SUBJECT: TMI-1 RESTART -- REACTOR WATER LEVEL
MONITORING

Three Mile Island Nuclear Station, Unit 1 (TMI-1)
Operating License No. DPR-50
Docket No. 50-289
Inadequate Core Cooling (II.F.2)

FIGURE - 1
MIXTURE HEIGHT

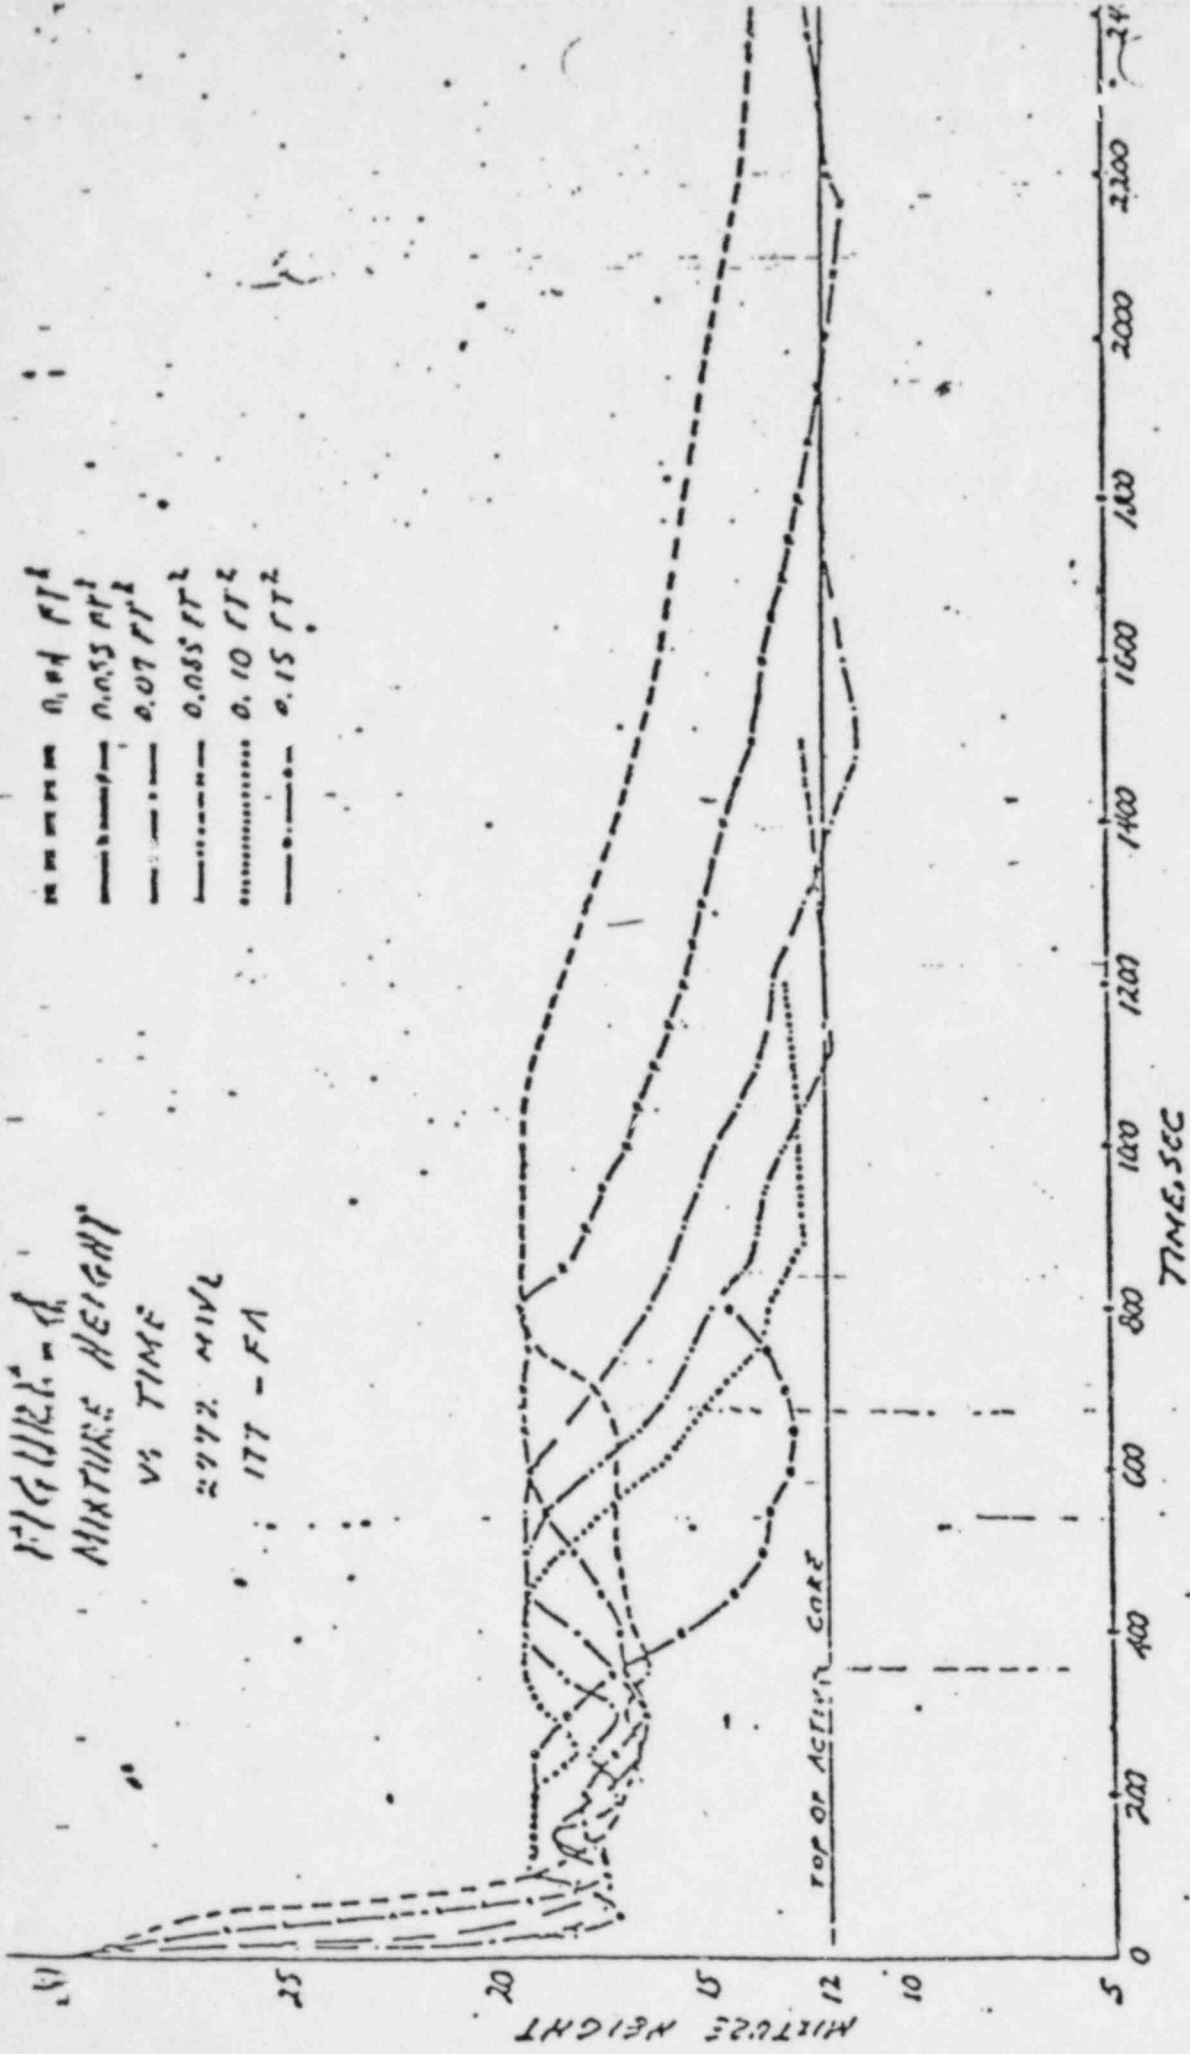
We do not yet understand how water level could be used for an analogous purpose. The water level and its rate of change with time vary enormously for different size leaks and leak locations. The attached figure 1, for example, shows the calculated water level for different size small breaks. For large breaks the level drops even more quickly and results in temporary uncovering of the core. For all of these leak sizes and locations, however, the emergency core cooling systems will function to ensure that ICC does not occur. We have found no method by which water level information during a real accident could be interpreted to indicate that the emergency core cooling systems were not functioning as intended and/or that inadequate core cooling was being approached. We have scheduled meetings with each of the PWR vendors and plan to discuss this matter with them.
